# Access Compliance Report

## Public Rights-of-Way

| Intersection ID: 48865                  | Main Street: TIGRESS_CT | Cross Street: ERWIN_RD                  | Location: W            |
| ADA ID: C4805A6C4DA7                    | Ramp Type: PerpDiag     | Initial Pass/Fail: Fail                 | Overall Compliance: No |

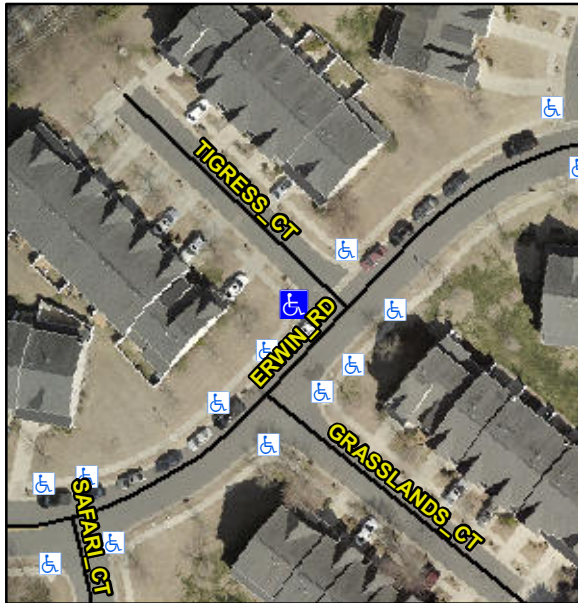
**Not Found, R304.2.2, R304.5.3**

| Compliance | Description           | Data  | Compliance | Description                 | Data  |
|------------|-----------------------|-------|------------|-----------------------------|-------|
| N/A        | Ramp Length (in)      | 48.0  | No         | Ramp Slope (%)              | 8.7   |
| Yes        | Ramp Width (in)       | 48.0  | No         | Ramp XSlope (%)             | 4.3   |

**Remove & Replace Curb Ramp With Two New Directional Ramps or Equivalent.**
